FOR APPROVAL OF THE FOYNES TO LIMERICK ROAD (INCLUDING
ADARE BYPASS) COMPRISING:

ORAL HEARING

Brief of Evidence

Noise and Vibration

<table><tr><td>Designed: JH</td><td>File:</td><td>Status: E.I.A.R.</td></tr><tr><td>Checked: GR</td><td>Scale: 1:5000 (@ A3)</td><td>Drawing No: Fig 12.10</td></tr></table>

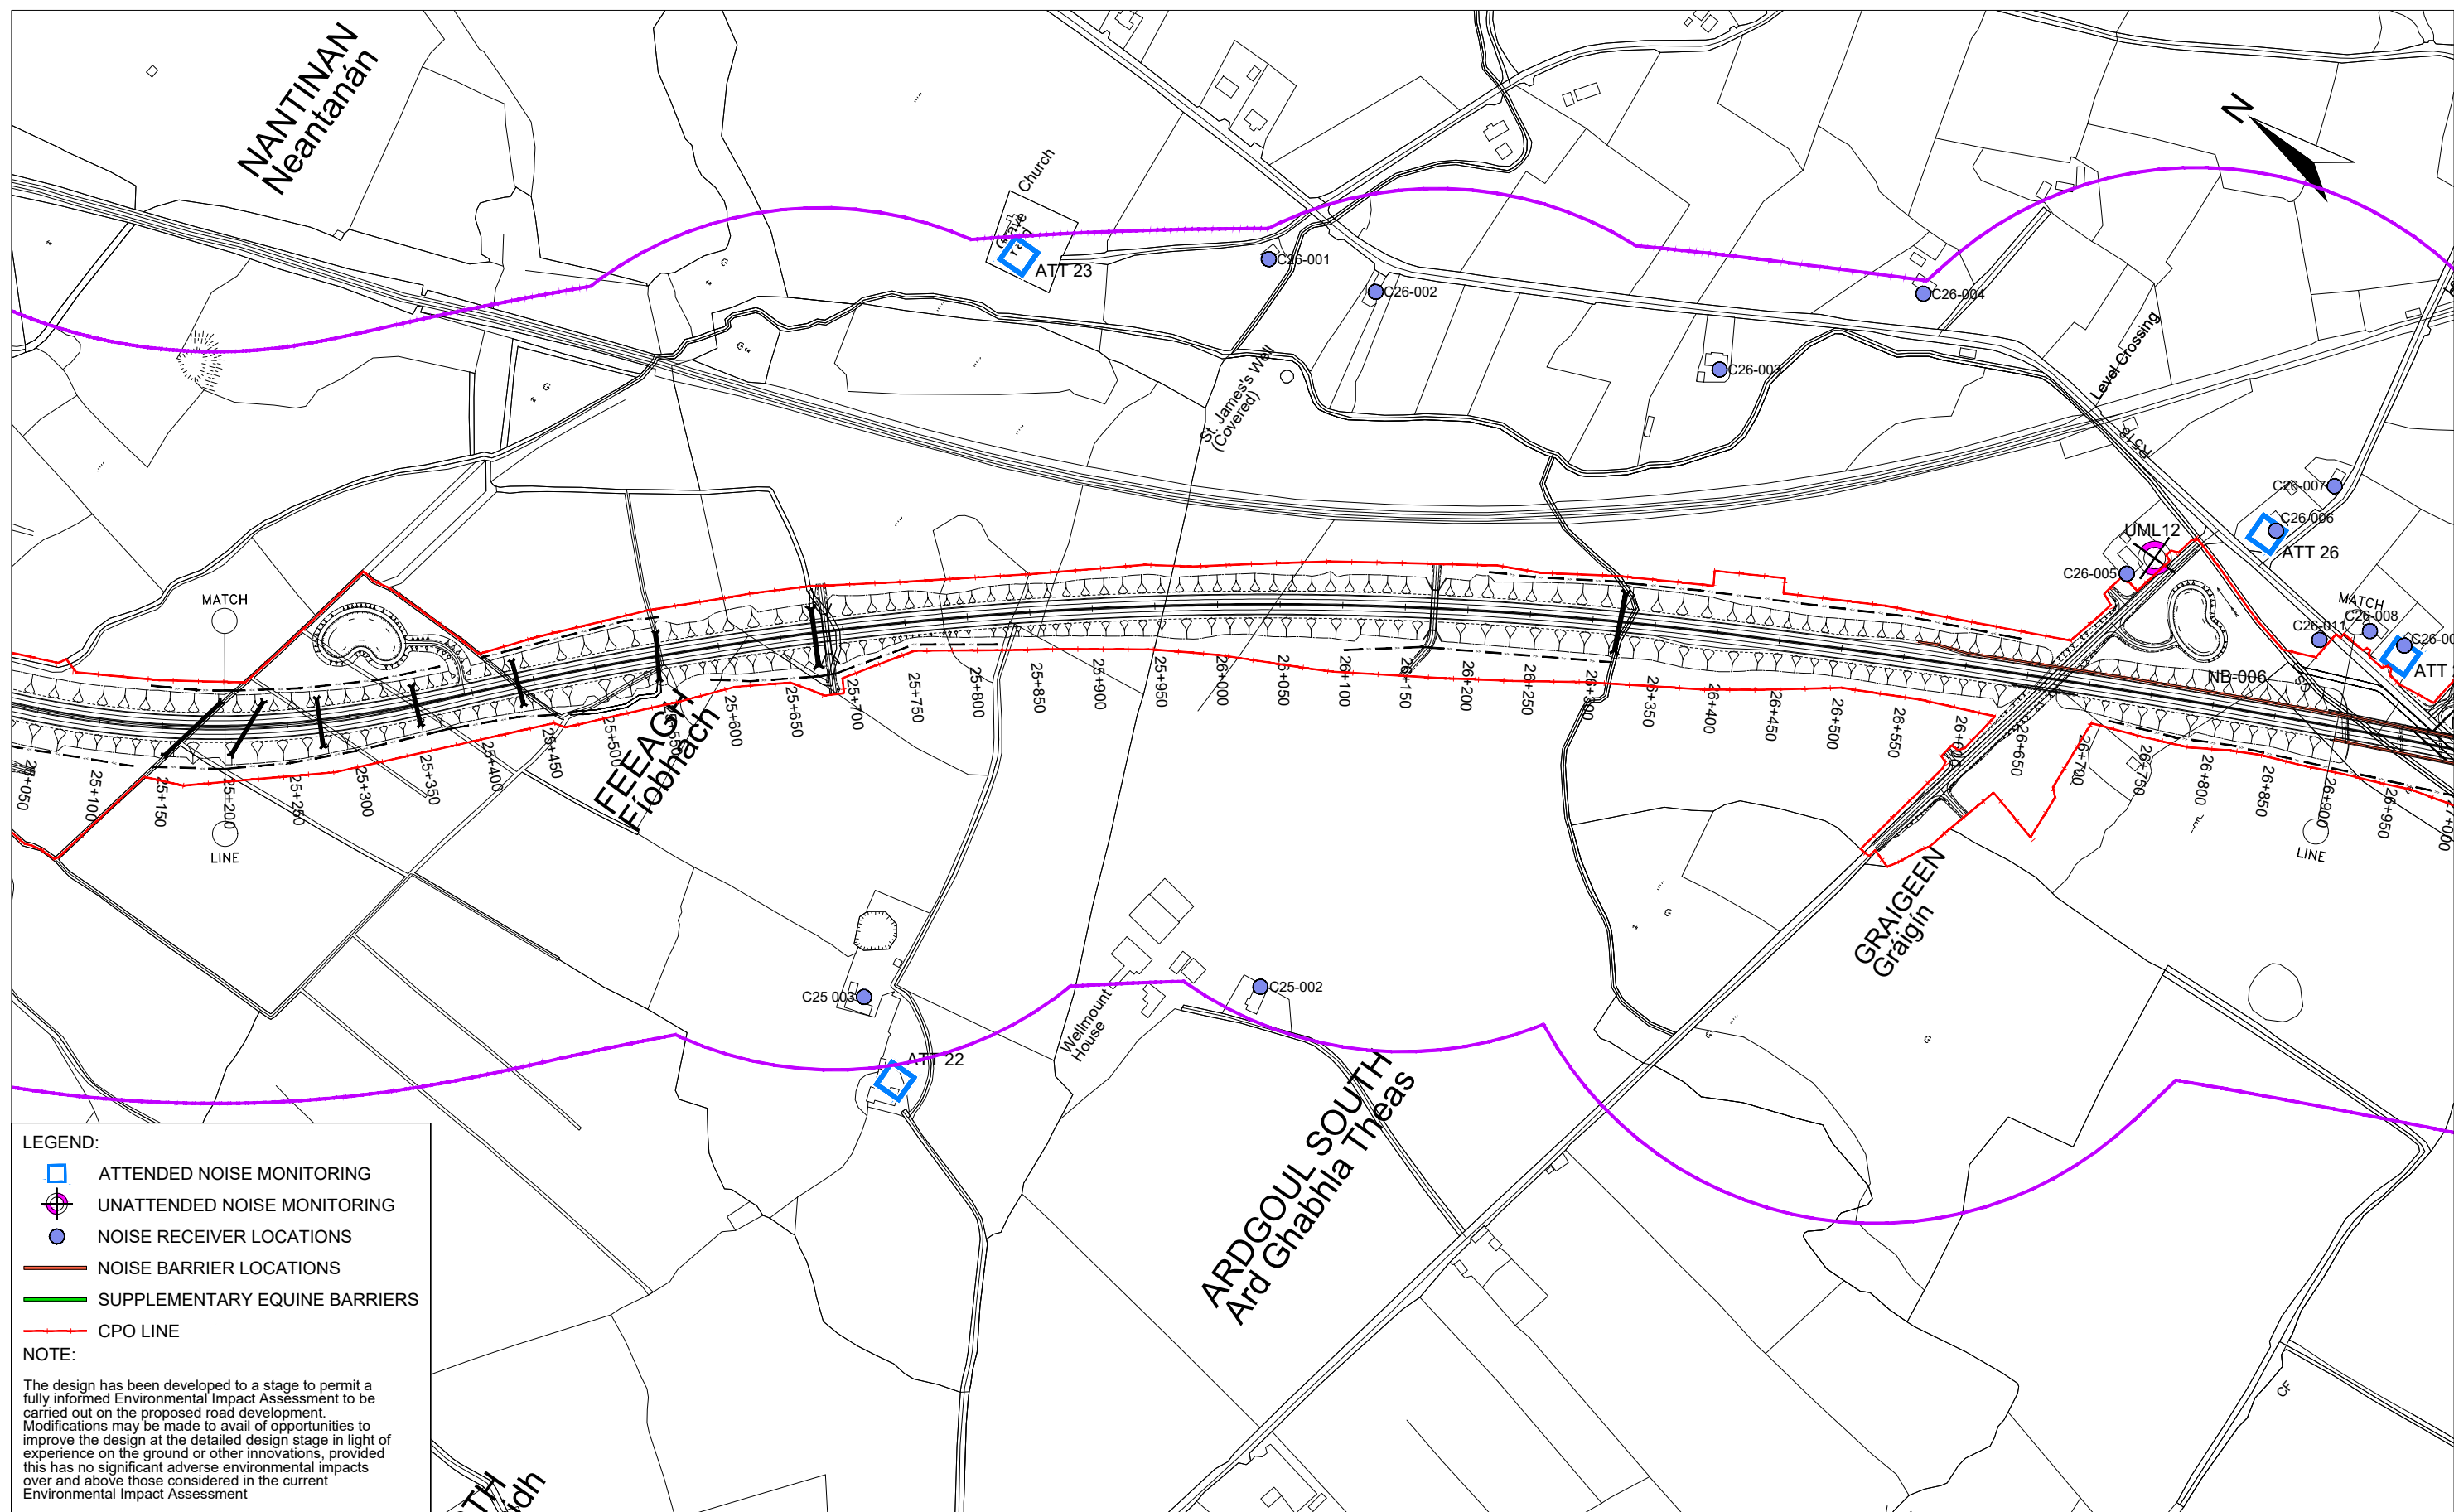
- Submission SCH-16: This submission refers to the property number C25-003 located at Feeagh. The modelled location is illustrated in Figure 12.10. The operational noise level associated with this property in EIAR Appendix 12.1 is 52dB L_{den} which is below the operational traffic noise design goal. Additional noise mitigation is therefore not required at this location.

<table><tr><td>Designed: JH</td><td>File:</td><td>Status: E.I.A.R.</td></tr><tr><td>Checked: GR</td><td>Scale: 1:5000 (@ A3)</td><td>Drawing No: Fig 12.16</td></tr></table>

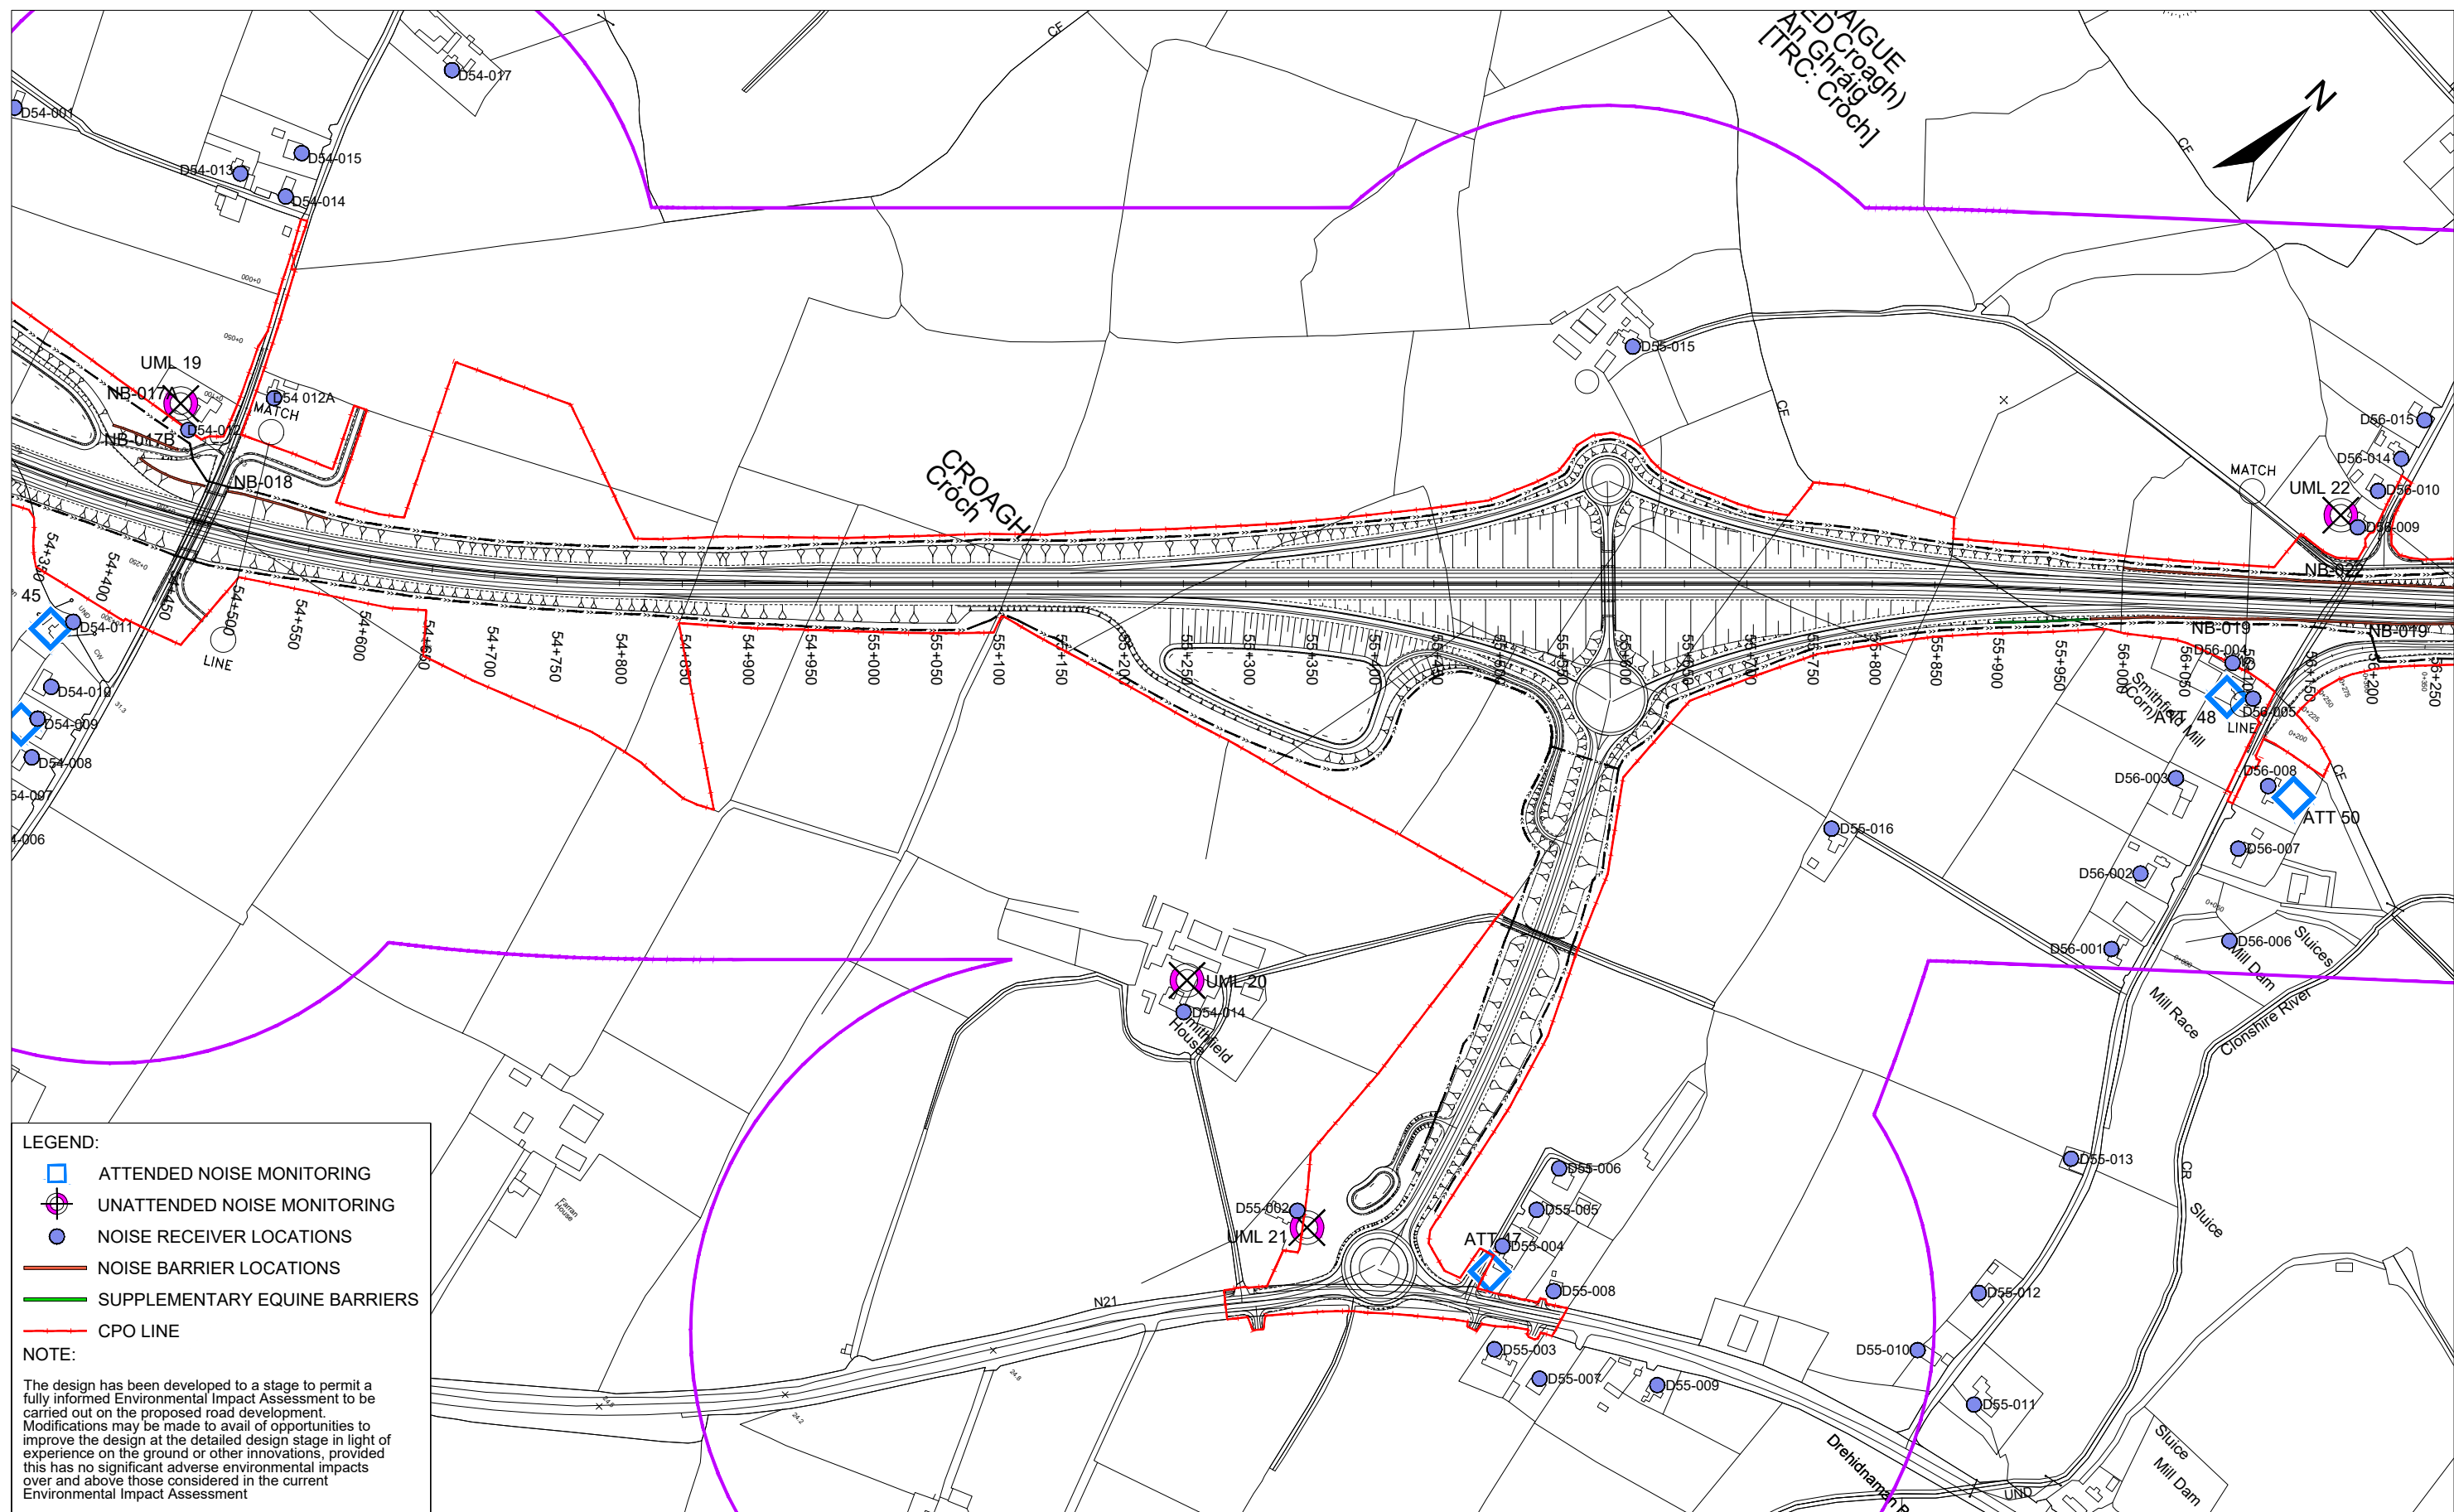
- Submission SCH-55: This submission refers to the property number D55-015 in the vicinity of Croagh. The modelled location is illustrated in Figure 12.16. The operational noise level associated with this property in EIAR Appendix 12.1 is 57dB L_{den} which is below the operational traffic noise design goal. Additional noise mitigation is therefore not required at this location.
